**From:** Maruna, Thomas  
**Sent:** Thursday, September 04, 2014 11:14 AM  
**To:** Allison Kennedy (akennedy@ebsi.com); 'smcgregor@ebsi.com'  
**Cc:** 'adyer@ebsi.com'; Melhem, Randa  
**Subject:** Information Requested: BLA STN 125562/0 - Please Respond by September 15, 2014

We are reviewing your July 25, 2014 biologics license application (BLA) indicated for the treatment of adult and pediatric patients with toxemia associated with inhalational anthrax for the following:

<b>STN</b>	<b>Name of Biological Products</b>
BL 125562	Anthrax Immune Globulin Intravenous (Human)

We determined that the following information is necessary to continue our review:

Fig: Summer Conditions

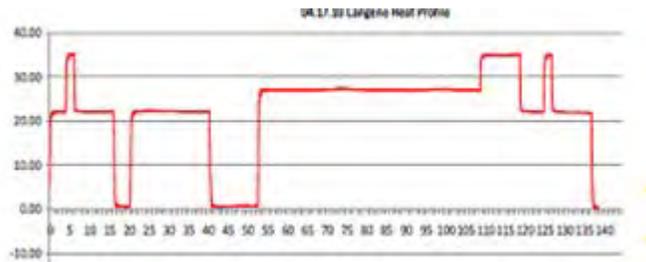
- a. Please provide data to demonstrate that the dataloggers are placed in worst case locations (cold and hot spot for both the min and max loads).

The temperature profiles for the max and min loads are quite different:

- b. For the min load, it looks that the center datalogger marked a temperature very close to the limit in the initial (b) (4). The loading of the vials in the shipper should be adjusted to prevent the temperature spike. Please provide a risk assessment, data and justifications.
- c. It is clear from the graphs that the recorded temperature fluctuates with the simulated temperature cycle – thus if the temperature is below zero, there is a possibility that the temperature (max load, (b) (4) may drop below (b) (4), thus causing stopper integrity issues. Please provide a risk assessment and data to assure that the temperature of the shipment will not drop below (b) (4).
